## PRODUCT CHANGE NOTIFICATION (PCN)

### A-MCSP60100 MODULAR CABLE

PCN 20220822\_A-MCSP60100

CHANGE OF DATA SHEET  
CHANGE OF DATA SHEET  
New Draw.-No. ASS\_7542\_CAreV06

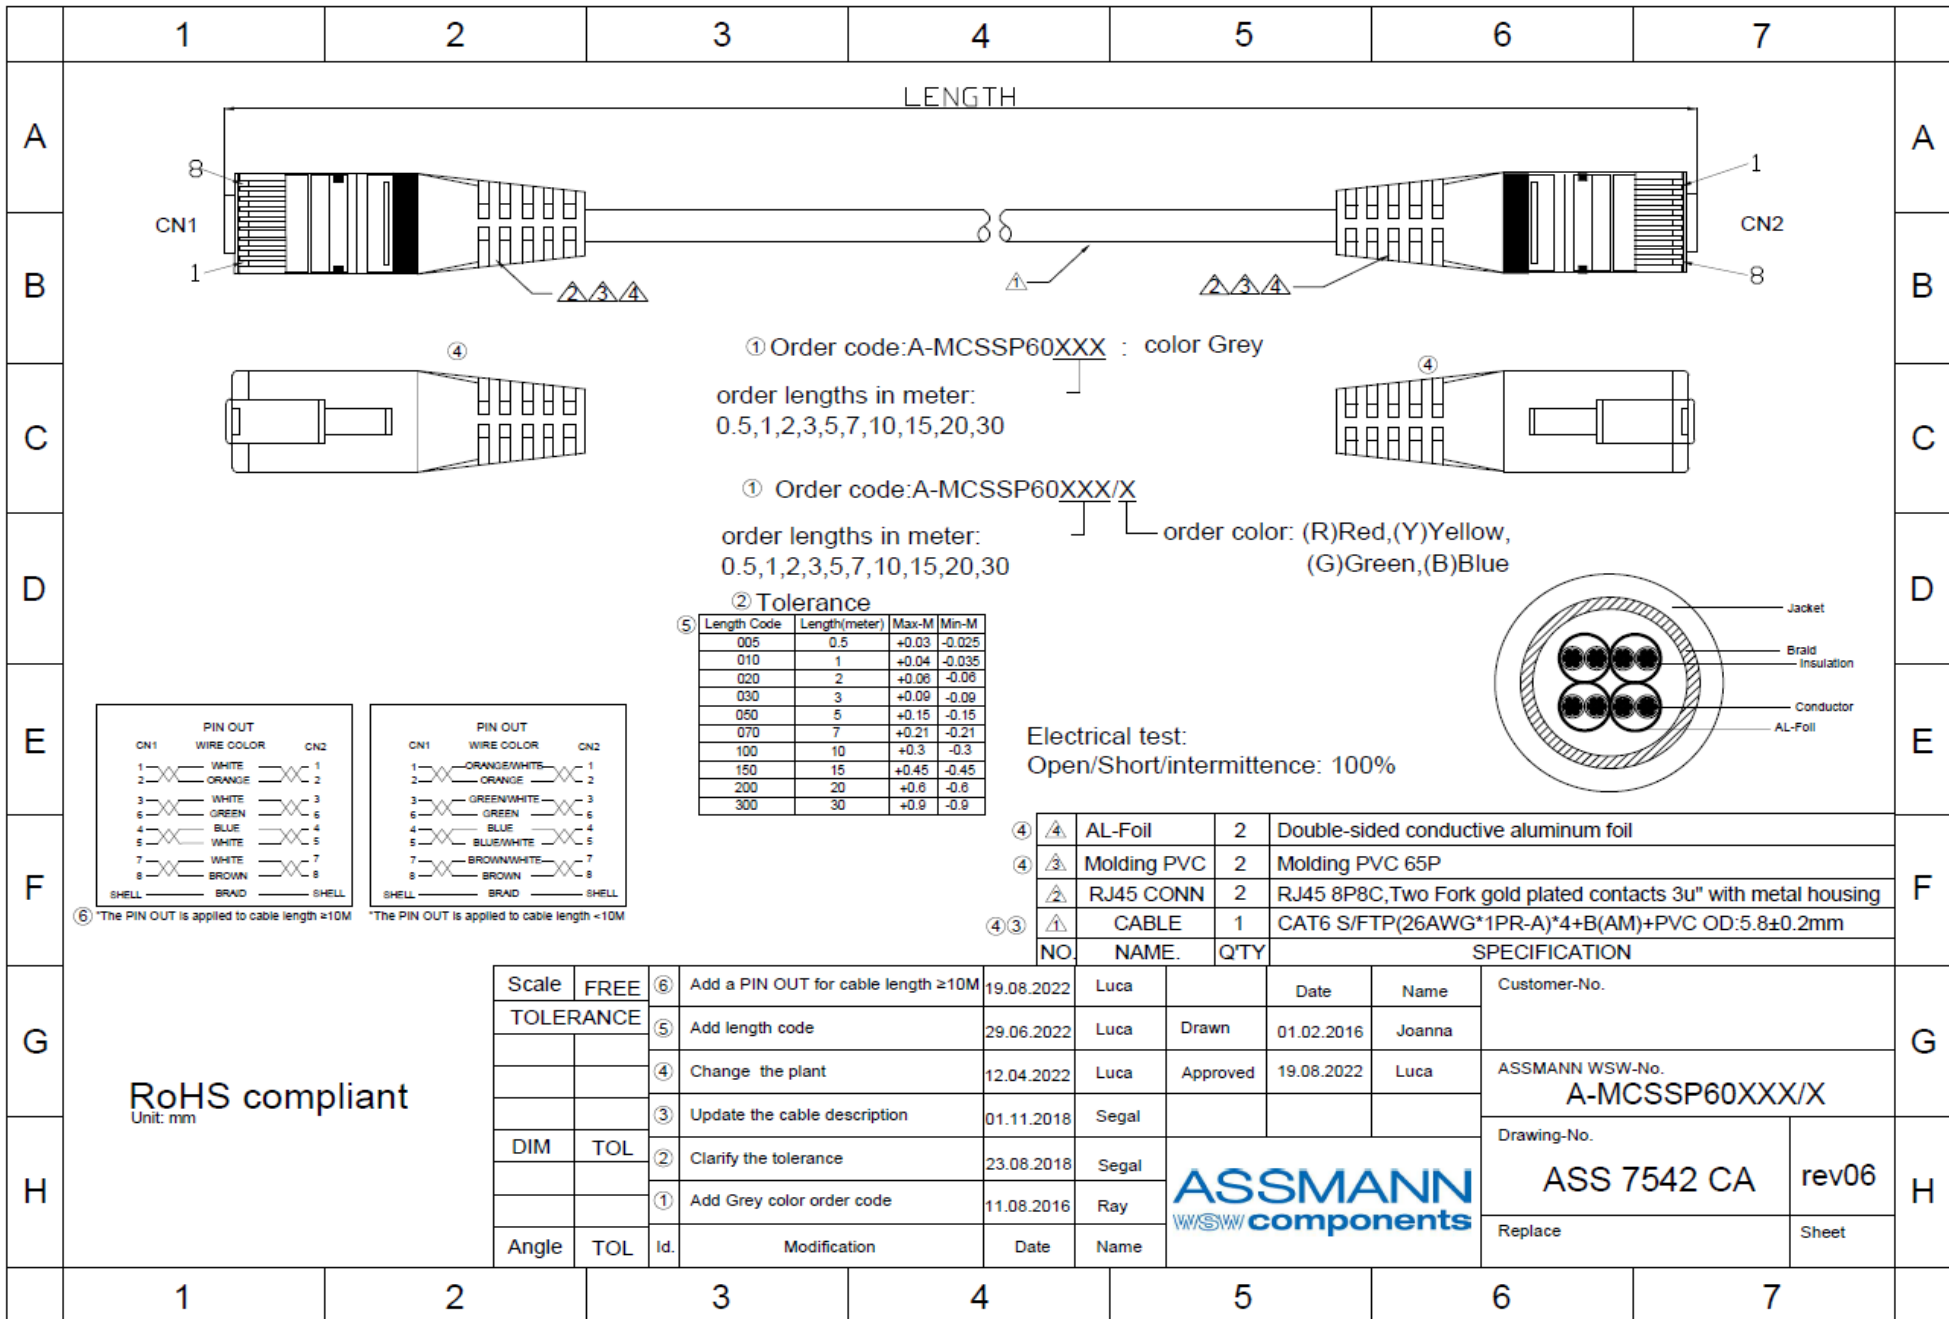
CHANGE OF MATERIAL PARAMETERS OR PROPERTIES  
CHANGE OF MATERIAL PARAMETERS OR PROPERTIES

⑥ \*The PIN OUT is applied to cable length ≥10M \*The PIN OUT is applied to cable length <10M

Scale	FREE	⑥	Add a PIN OUT for cable length ≥10M	19.08.2022	Luca	Date	Name	Customer-No.
TOLERANCE		⑤	Add length code	29.06.2022	Luca	Drawn	01.02.2016	Joanna
		④	Change the plant	12.04.2022	Luca	Approved	19.08.2022	Luca
		③	Update the cable description	01.11.2018	Segal			
DIM		TOL	②	Clarify the tolerance	23.08.2018	Segal		
			①	Add Grey color order code	11.08.2016	Ray		
Angle		TOL	Id.	Modification	Date	Name	ASSMANN WSW components	
								ASSMANN WSW-No. A-MCSSP60XXX/X
								Drawing-No. ASS 7542 CA rev06
								Replace Sheet

PIN OUT																																																																																																																																																																																																			
CN1	WIRE COLOR				CN2																																																																																																																																																																																														
1	WHITE	—	—	—	1																																																																																																																																																																																														
2	ORANGE	—	—	—	2																																																																																																																																																																																														
3	WHITE	—	—	—	3

6	GREEN	—	—	—	6																																																																																																																																																																																														
4	BLUE	—	—	—	4																																																																																																																																																																																														
5	WHITE	—	—	—	5																																																																																																																																																																																														
7	WHITE	—	—	—	7																																																																																																																																																																																														
8	BROWN	—	—	—	8

SHELL		—	BRAID	—	SHELL																																																																																																																																																																																														
PIN OUT																																																																																																																																																																																																			
CN1	WIRE COLOR				CN2																																																																																																																																																																																														
1	ORANGE/WHITE	—	—	—	1																																																																																																																																																																																														
2	ORANGE	—	—	—	2

3	GREEN/WHITE	—	—	—	3																																																																																																																																																																																														
6	GREEN	—	—	—	6																																																																																																																																																																																														
4	BLUE	—	—	—	4																																																																																																																																																																																														
5	BLUE/WHITE	—	—	—	5																																																																																																																																																																																														
7	BROWN/WHITE	—	—	—	7

8	BROWN	—	—	—	8																																																																																																																																																																																														
SHELL		—	BRAID	—	SHELL																																																																																																																																																																																														
FOR DETAIL, PLEASE TAKE ATTACHED NEW DRAWING: FOR REFERENCE
